**Re: Final Engineering Review
Earth Removal Application
Rocky Meadow Cranberry Bog
ADE Project #2518.33**

PROPOSED TAILWATER POND & EARTH REMOVAL PERMIT PLAN
280 DUNBAR STREET WOODBRIDGE, VA 22191
ROCKY MEADOW CRANBERRY BOG
46 INGLE STANISHI DRIVE CLAYTON, VA 02330

RE: Engineering Review
Earth Removal Application
Rocky Meadow Cranberry Bog
G.A.F. Job No. 14-8312

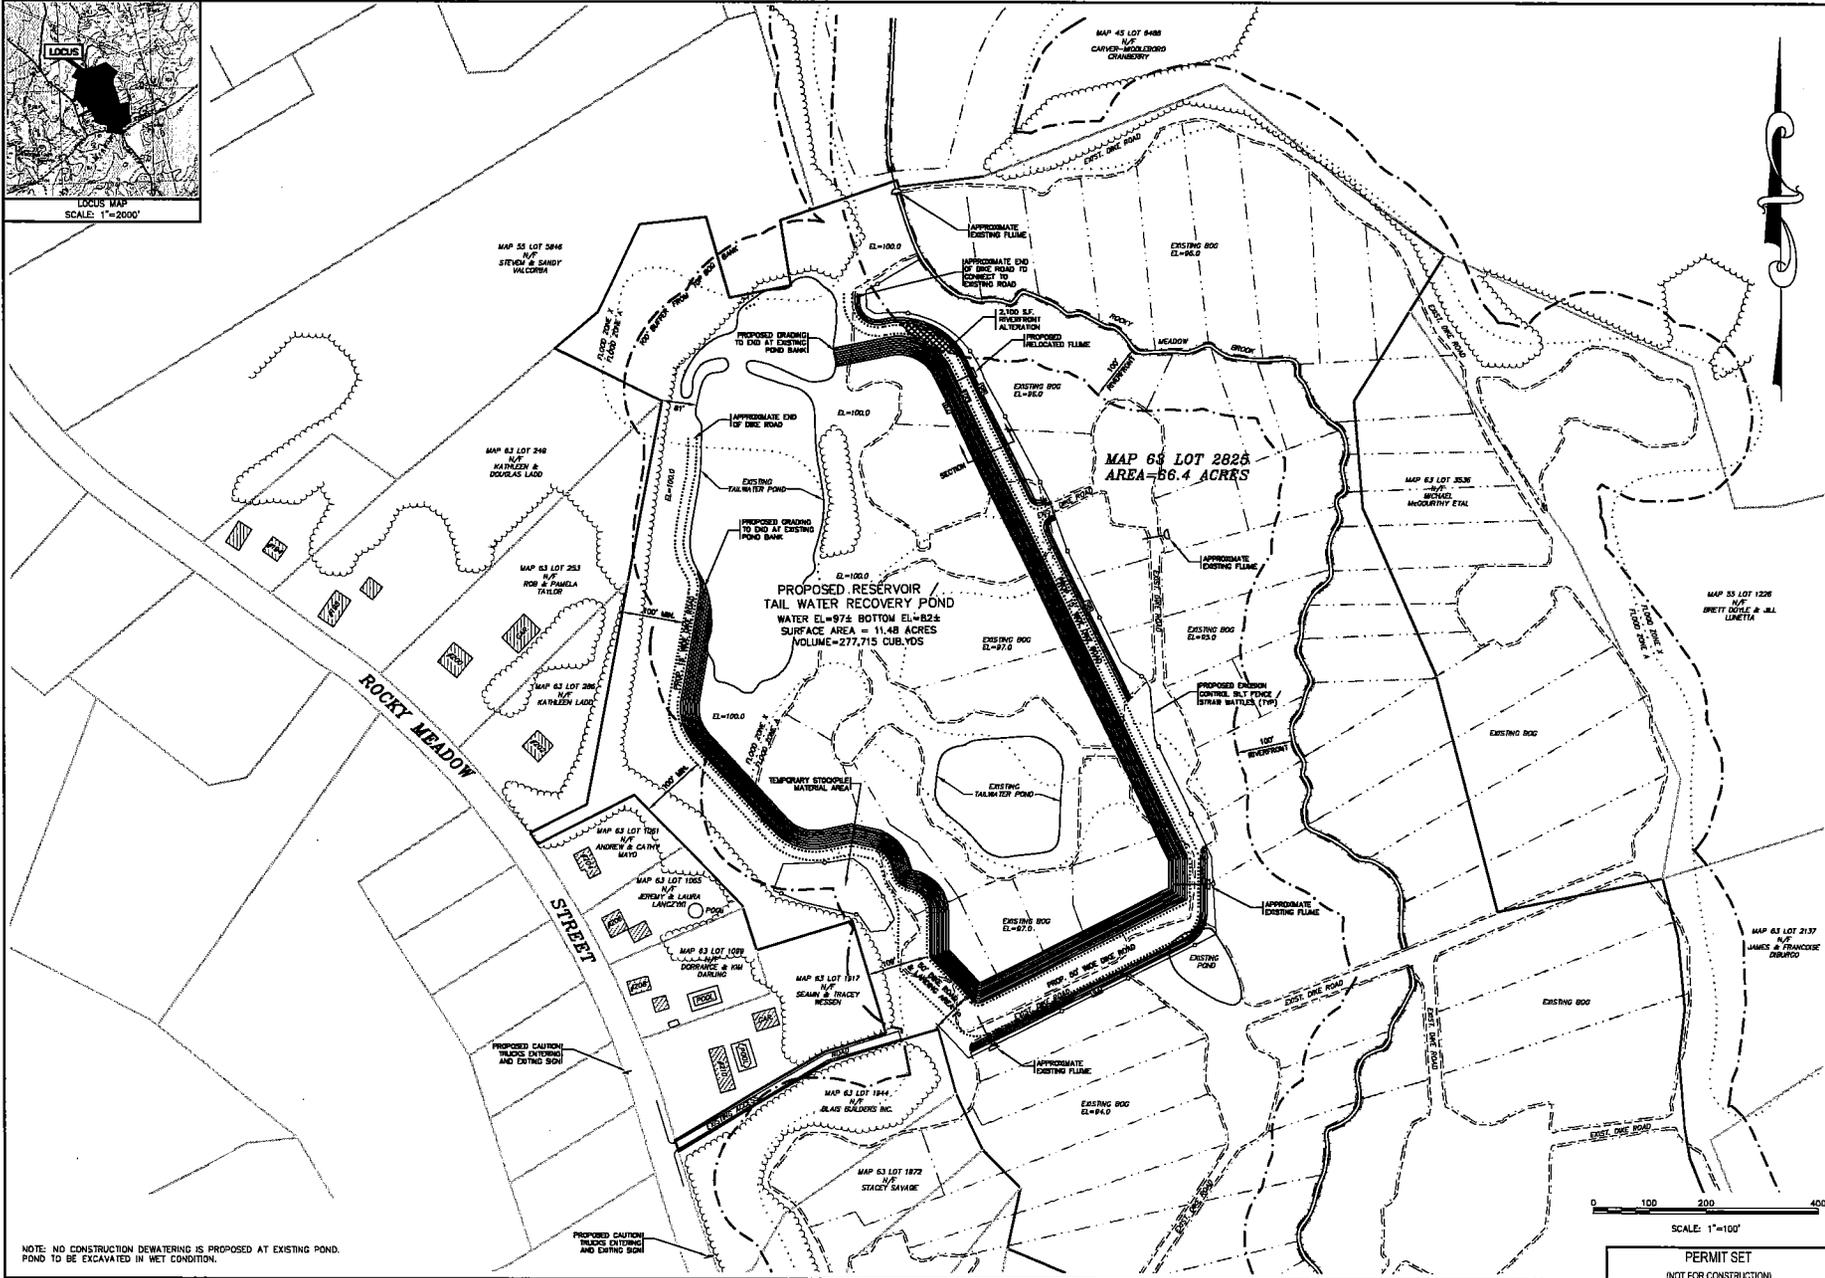
10. *Comment:* The water elevation and bottom elevation labels on sheet 1 are mixed up.

Response: The elevations have been revised as noted (corrected).

C125BN EROSION CONTROL BLANKET SLOPE DETAIL

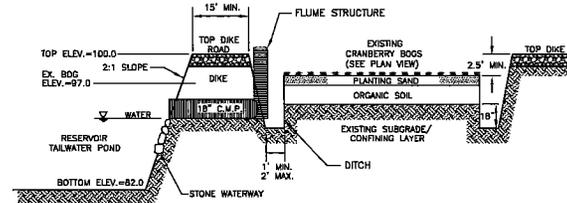
7. *Comment:* It is recommended that slopes steeper than 3:1 should be stabilized with an erosion control blanket. Please amend the appropriate notes on the Site Plan and in the Project Plan.

4. *Comment:* The proposed 2:1 slopes of the earth removal area may be subject to erosion during both on-going and post construction. The Applicant has provided a method of temporary stabilization under the seeding and mulching notes but additional measures such as stump grindings may be required if the provided methods are not sufficient.

Response: There are no exterior slopes other than dike slopes. All slopes are sloped to bogs or to the tailwater/irrigation pond. Slopes of 2H:1V are shown. We have added notation requiring erosion control blankets.

Response: Erosion control blankets are specified and have been added to the plan.
